Core Bus Corridor 13: Bray

17th April 2020

Leeson Street Lower (maps 3-4)

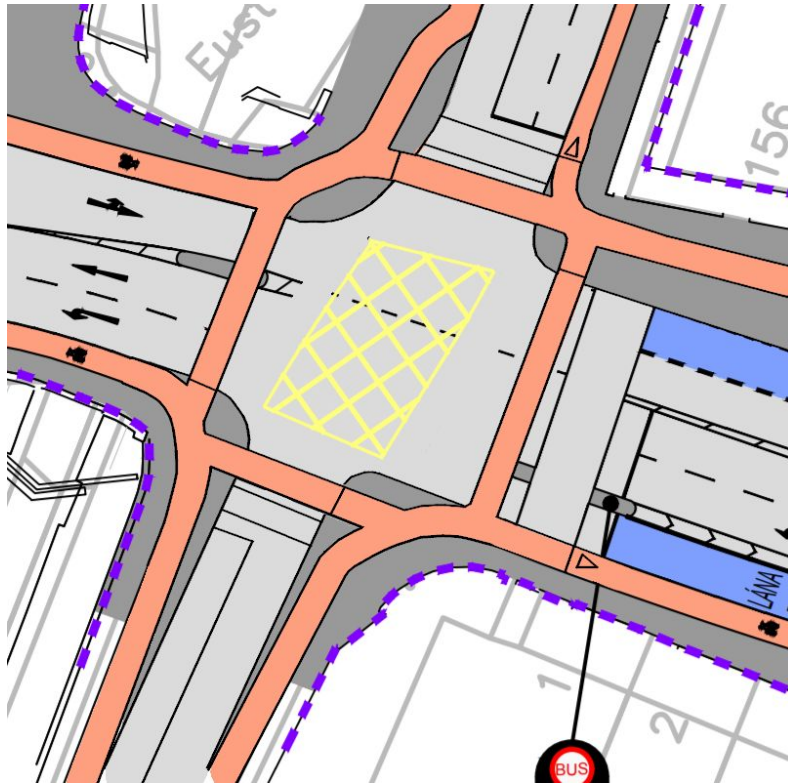
As discussed in our original submission, the stretch of Leeson Street between Hatch Street and Stephen's Green is far too narrow for the proposed layout. At present, the two cycle lanes are unsegregated and extremely narrow. Yet even under these circumstances, there is not enough space for three full lanes for motor traffic. The cycle paths desperately need to be widened and segregated. Therefore, the solution must involve reducing the road to two traffic lanes on approach to this junction. Diversions for private traffic and/or bus priority measures can ensure bus priority.

Reducing the road to two lanes would also create space which could be used to install island bus stops.

Between Hatch Street and Fitzwilliam Place, the proposed 4 lane layout would require busy footpaths to be narrowed and prevent the installation of island bus stops. We would like to see the outbound traffic lane removed, and the space used to install wider footpaths, island bus stops, and a buffer between the cycle path and the road. Drivers coming from the Fitzwilliam or Baggot Street areas could get to Leeson Street Bridge via Fitzwilliam Place instead. Only a small number of drivers parked on roads like Leeson Close or a small part of Pembroke Street Upper would be inconvenienced in any way.

Morehampton Road (maps 7-8)

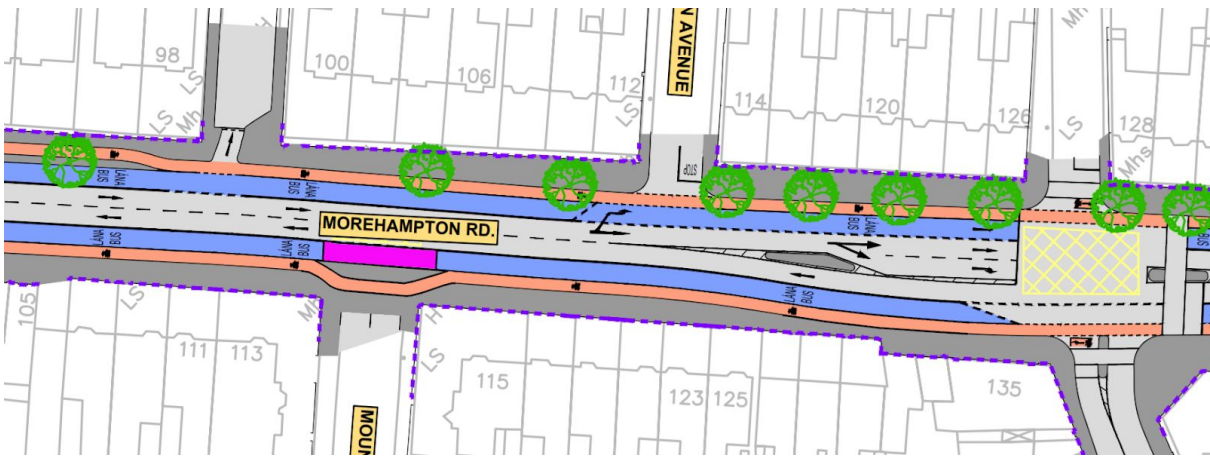
There are a number of bus stops along this stretch that should be relocated to make them safer for people on bikes.

- The first outbound bus stop could be moved to outside the Hampton Hotel where a grass verge could be converted into an island bus stop.
- The outbound Belmont Avenue stop could also be relocated to the entrance to Mount Eden

Donnybrook (Map 9)

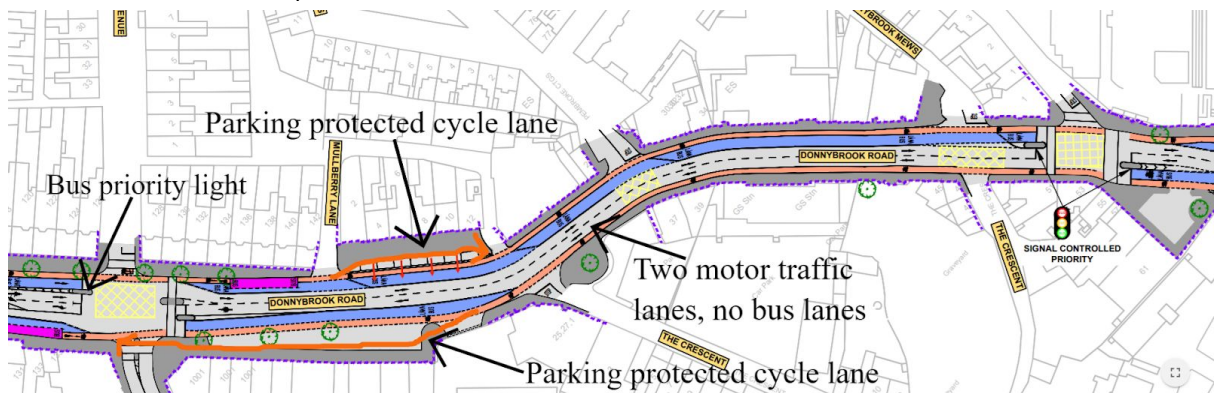
We welcome the decision to narrow the road between Donnybrook Fire Station and Brookvale Drive to accommodate cycle lanes, but this will not be enough to make the road safe for people cycling. This only makes space for 1.5 m wide cycle lanes in each direction without any space for segregation. Given the high traffic volumes and speeds on this road a cycle lane this narrow would make cycling here extremely uncomfortable and scary.

Even more concerning is that the lack of space will mean that buses and other large vehicles will be likely to encroach on the cycle lanes as they go around the bends in the road. This could make the design lethal for people cycling.

With barely 12 m between the footpaths, the only layout that is safe and comfortable for all road users would be two motor traffic lanes and two 2 m wide cycle paths, with a physical buffer between the cycle paths and the road. This would require an outbound bus priority light to be installed at Belmont Avenue.

Reducing this stretch to two lanes would also make it possible for the cycle path to bypass the parking bays, and for island bus stop to be installed at the outbound Belmont Avenue stop.

Beaver Row/Anglesea Road Junction (Map 10)

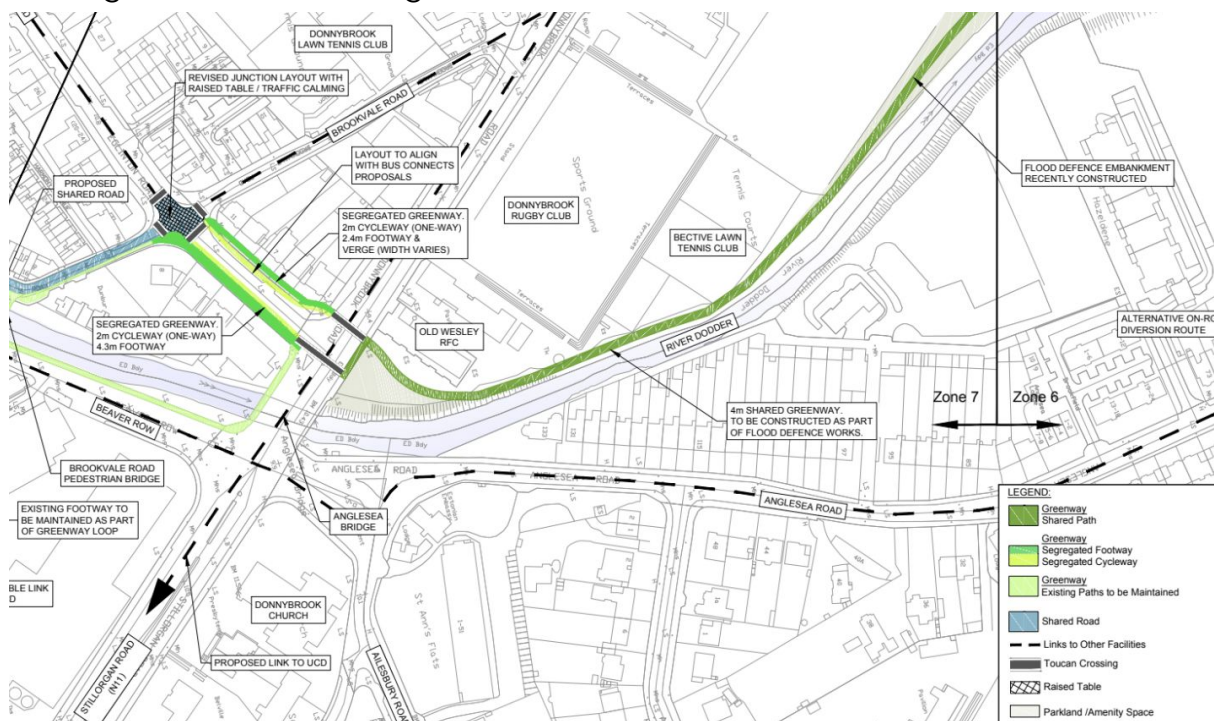
We're very welcoming of the design change to bypass the busy bus stop just north of the Eglinton Road junction. This also makes crossing Eglinton Road much safer for people cycling.

We're disappointed to see the outbound bus stop is not bypassed. If our 2 lane recommendation above is implemented, this bus stop could be moved further north where it could be bypassed.

There is no reference in the designs to the Dodder Greenway which the NTA have recently taken ownership of. The Dodder Greenway preferred route has toucan crossings which CBC13 designs have not included.

The outbound bus stop at Donnybrook Bus Garage must be an island bus stop. It's completely unacceptable to put cyclists and buses in conflict here, particularly as it is at the bottom of a hill. To achieve this space, we recommend realigning the median and reducing the N11 outbound to one lane from Donnybrook Church to at least Airfield Park. Reduced traffic volumes from lane reduction in Donnybrook will mean reduced traffic volumes along this stretch of the N11. A bus stop bypass here is more important than retaining under-utilised car carrying capacity.

Extract of map 21

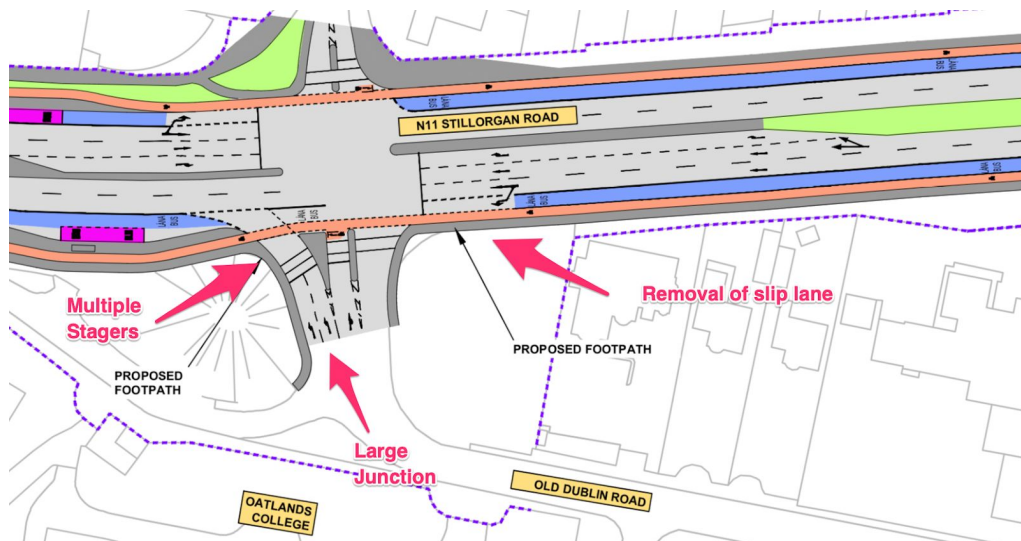
We recommend that the Old Dublin Road junction be closed to traffic and all traffic be diverted via Lower Kilmacud Road (map 22). As well as reducing the number of junctions along the main route, it will help to improve traffic flow on the main Stillorgan Road.

However, if this design is persisted with, the junction could be improved further. The junction is still too large. This leaves pedestrians with 3 staggered crossings. It is unclear why left-turning traffic needs two turn lanes.

We would also encourage the design team to investigate the nature of traffic using this junction. Given the proximity of this junction to the Lower Kilmacud Road junction, it might be feasible to close off the Old Dublin road junction and turn the road into a cul de sac.

Kill Lane (Map 29), Old Bray Road Junction (Map 31), Clonkeen Road Junction/Cornelscourt (Map 33), Johnstown Road (Map 35), entrance to Cherrywood SDZ (Map 37)

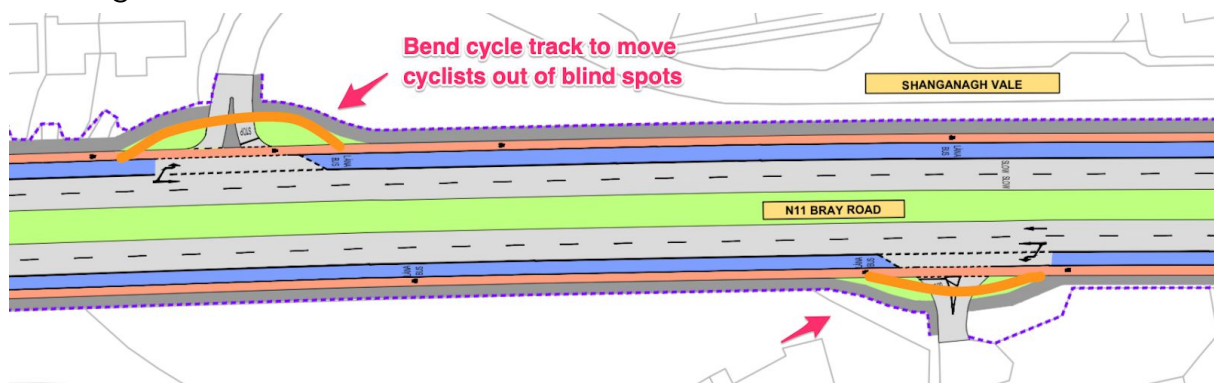
A Dutch-style junction as at Newtownpark Avenue is strongly needed at these junctions. The entrance road to Cherrywood SDZ will need to be redesigned to be consistent with junction treatment throughout the N11. The current junction design does not keep cyclists safe from turning traffic.

This stretch of the N11 has increased speed limits so a buffer between the bus lane and cycle track is of heightened importance here.

The lack of pedestrian footpath from Map 31 to Map 37 will result in pedestrians walking on the cycle track. We recommend adding footpaths on either side of the road.
